SLOVENSKI STANDARD SIST EN 15273-1:2013/kFprA1:2016

Železniške naprave - Profili - 1. del: Splošno - Skupna pravila, ki se nanašajo na infrastrukturo in železniška vozila - Dopolnilo A1

FINAL DRAFT EN 15273-1:2013

FprA1

Add under Formula (21):

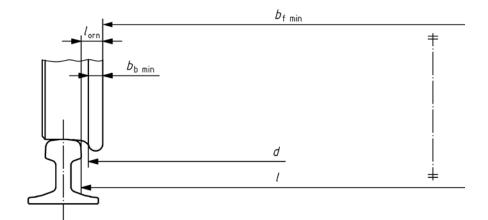
"The value F is to be taken into consideration on the outside of the static reference profile as a fixed value (see Annex B).".

Replace the existing Figure B.21 with the following:

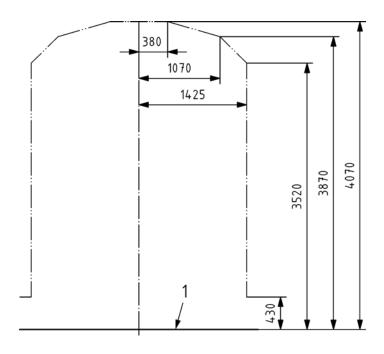
5 Change to Subclause B.6.1.5.1, Static reference profile for the lateral parts and upper parts

Replace the existing Figure B.22 with the following:

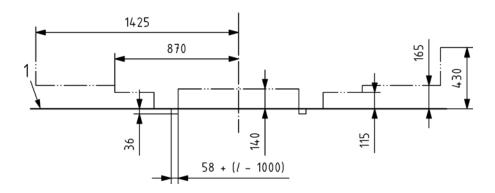
6 Change to Subclause B.6.1.5.2, Static reference profile for the lower parts

Replace the existing Figure B.23 with the following:

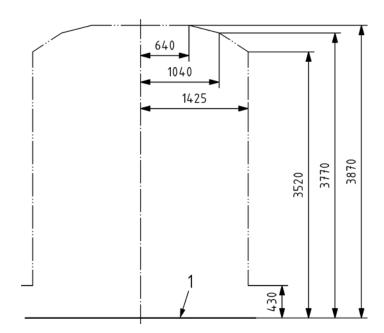
7 Change to Subclause B.6.1.6, Static gauge GED10

Replace the existing Figure C.4 with the following:

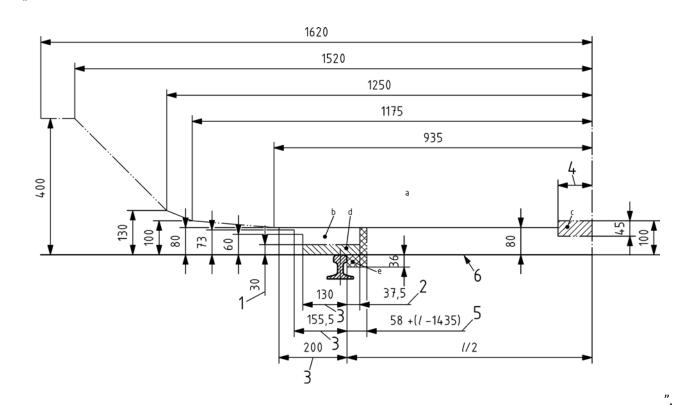
9 Change to Subclause C.1.2.1.2, Kinematic reference profile for the lower parts corresponding to the lower limit of vehicles not passing over either marshalling humps or rail brakes in an active position
